MIL-V-8608A
AMENDMENT 2
9 November 1966
Superseding
AMENDMENT 1
21 June 1966

MILITARY SPECIFICATION

VALVES, FUEL SHUTOFF, ELECTRIC MOTOR OPERATED

This amendment forms a part of Military Specification MIL-V-8608A, 19 April 1963, and is mandatory for use by all Departments and Agencies of the Department of Defense.

FIGURE 3. Wiring diagram

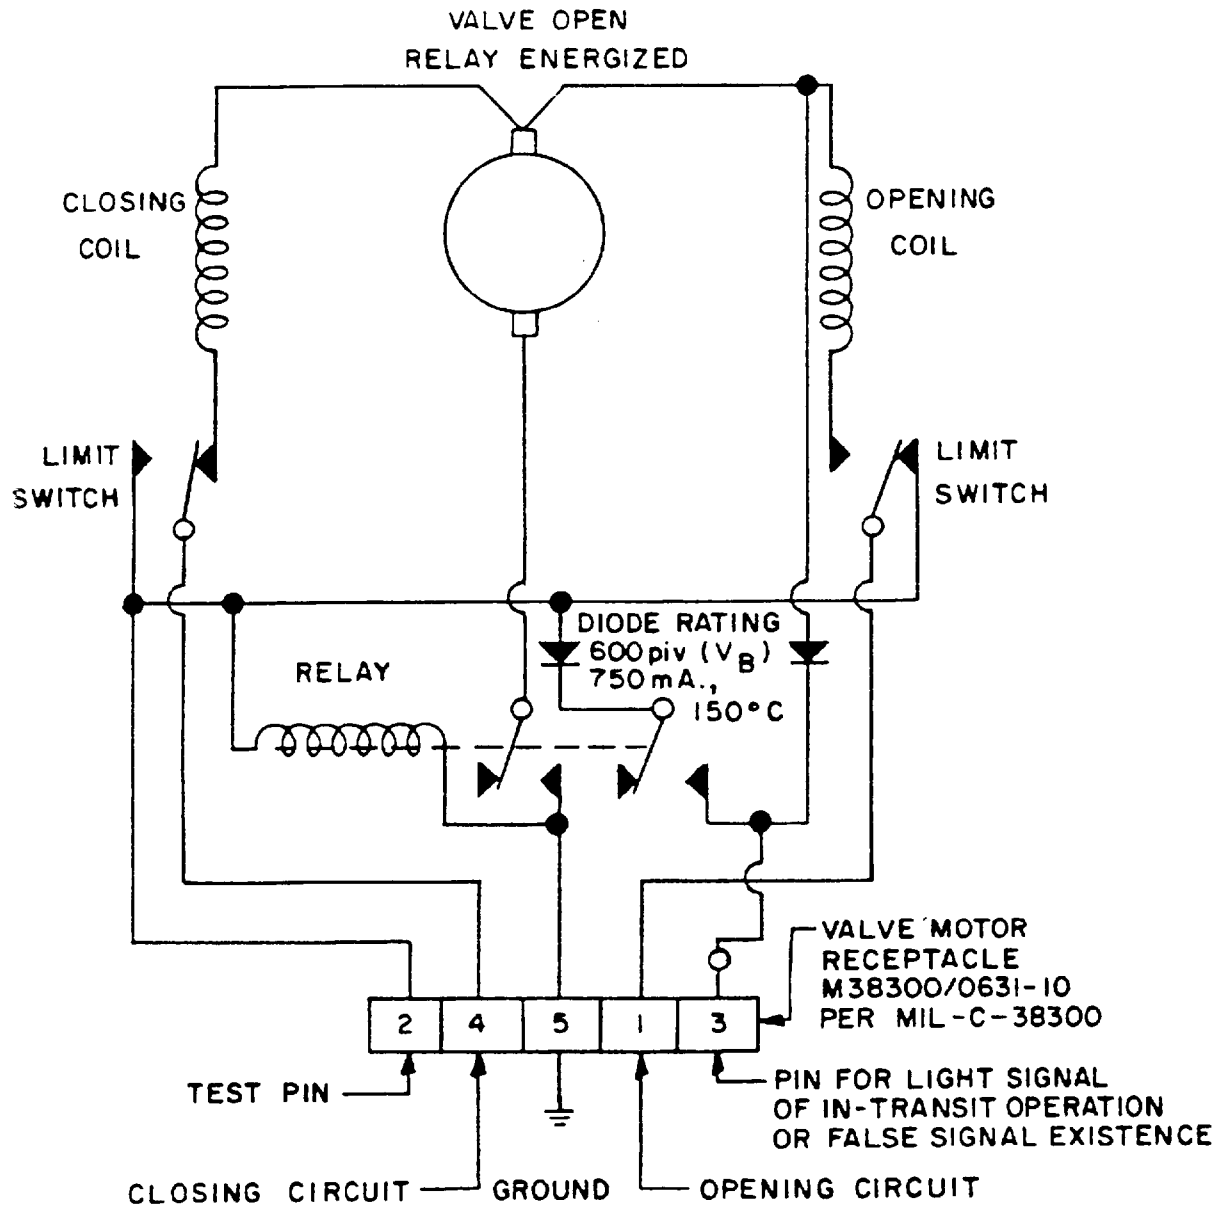
Page 3, paragraph 3.3.5: Delete, and substitute:

Page 4: (a) Paragraph 3.5.5: Delete, and substitute:

(b) Paragraph 3.5.7: Delete, and substitute:

(Add new figure 3 Wiring diagram, attached.)

(d) Add a new paragraph 3.5.10:

"3.3.5 Indicator circuits. Indicator circuits shall be provided in accordance with figure 3."

"3.5.5 Electrical connectors. Electrical connectors shall conform to MIL-C-38300 of the part number shown on figure 3."

"3.5.7 Electrical failure. The valve electrical circuit shall conform to figure 3 to provide protection against inadvertent actuation of the valve due to electrical short circuits. The valve shall not change positions due to electrical power failure."

"3.5.10 Semiconductors. Diodes used in the valve electrical circuit shall be one of the "preferred" types selected from MIL-STD-701 with a minimum rating as specified on figure 3."
